**PLANNED UNIT DEVELOPMENT &
SUBDIVISION STAFF REPORT****Date: October 17, 2019**

NAME Addison Woods Subdivision, Resubdivision of

LOCATION 3450 Girby Road
(North side of Girby Road 160'± East of Hillcrest Road)

SITE PLAN

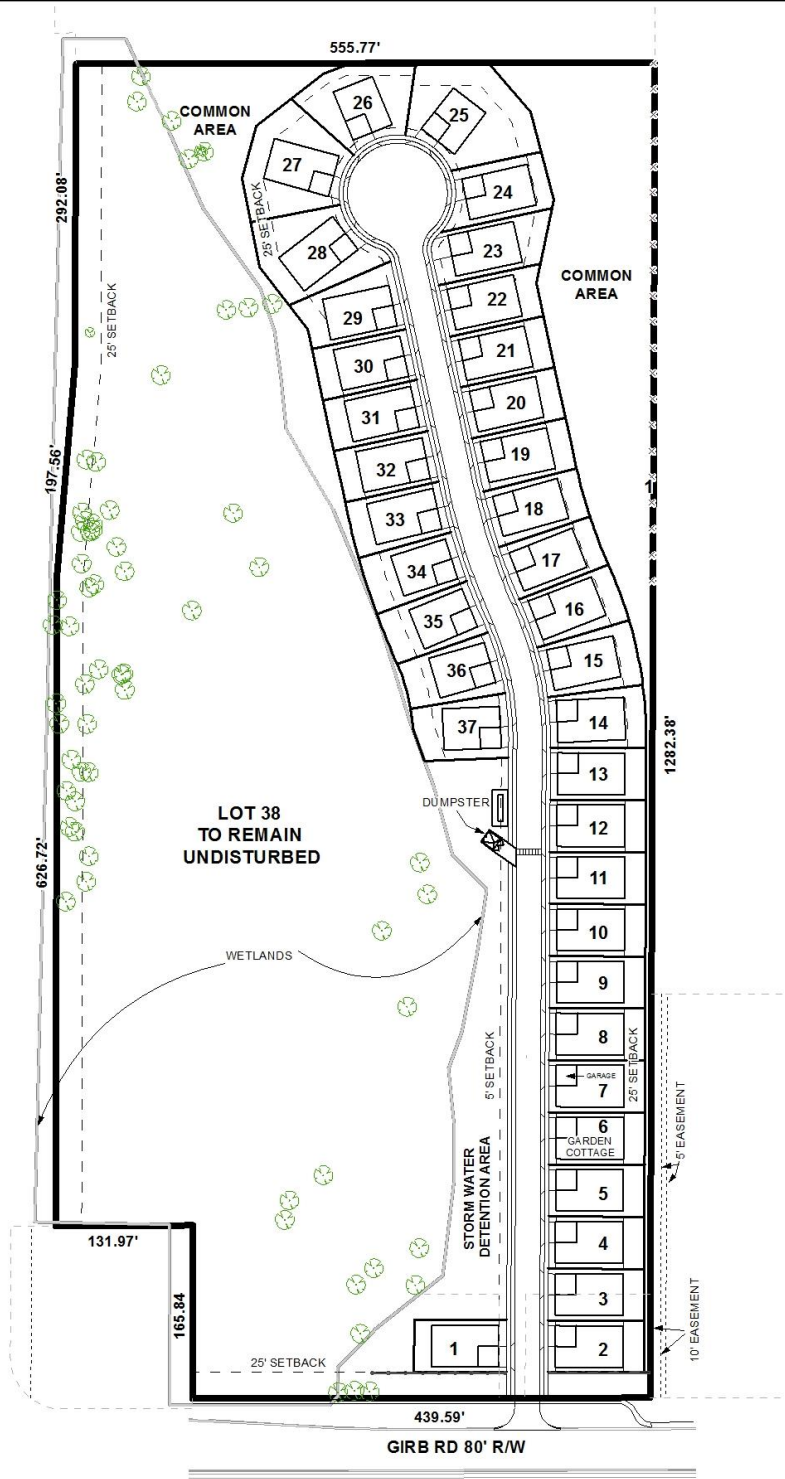
The preliminary plat depicts 34 of the proposed lots will be less than the minimum required lot size of 7,200 square feet, with lot sizes ranging from 4,393 square feet to 6,742 square feet. Additionally, 29 lots are less than 60 feet wide. Due to the reduced size of the lots, the applicant is requesting that the front and rear setbacks be reduced, and that the maximum allowable site coverage be increased. Tables are provided on the PUD site plan with the proposed setbacks and site coverage. The B-1 zoning of the property allows a 45% maximum site coverage; the applicant is proposing 21 different site coverages ranging from 20.8% to 56.6% - the applicant should reconsider this approach and, perhaps, simplify the criteria. If approved, this information

The proposed private street appears to have a non-compliant right-of-way. Section VIII.E.2.c. of the Subdivision Regulations requires that private streets have a minimum right-of-way of 50 feet, and the plat depicts a 40 foot right-of-way. The right-of-way width should be revised to be the minimum required width. This may be achieved by shifting the lots on the West side of the street further to the West. This may result in the rear yards of some lots containing wetlands, but should not impact the buildable area.

Section VIII.E.2. has several other requirements that need to be addressed. First, the plat is required to have utility easements acceptable to the appropriate provider of utility services within the Subdivision, and there are none depicted. Second, the Final Plat should contain a note stating that the street is privately maintained and not dedicated to the public. Next, a note is required on the Final Plat stating that if the street is not constructed and maintained to City standards that 100% of the cost of the improvements will be assessed to the property owners (it should be noted that if the street is developed with a 40 foot right-of-way, it would not be eligible for City maintenance). Finally, a letter sealed by either a registered land surveyor or civil engineer must be submitted at the time the required seven copies of the Final Plat, stating that all of the requirements of Section VIII.E.2. of the Subdivision Regulations have been met.

- 1) Revision of the site coverage table to simplify the request;
- 2) Revision of the site plan to include the lot size table provided on the preliminary plat;

- 3) Revision of the plat to provide a minimum 50 foot wide right-of-way for the proposed private road;
- 4) Changing the proposed Lot 38 to either a Common Area or a Preservation Area;

- 5) Revision of the site plan to include utility easements acceptable to the appropriate provider of utility services within the Subdivision;
- 6) Placement of a note stating that if the street is not constructed and maintained to City standards that 100% of the cost of the improvements will be assessed to the property owners, if dedicated to the City;

- 7) Revision to accommodate any other requirements of Section VIII.E.2. of the Subdivision Regulations;
- 8) Revision of the site plan to reflect the previous dedication made along Girby Road; and
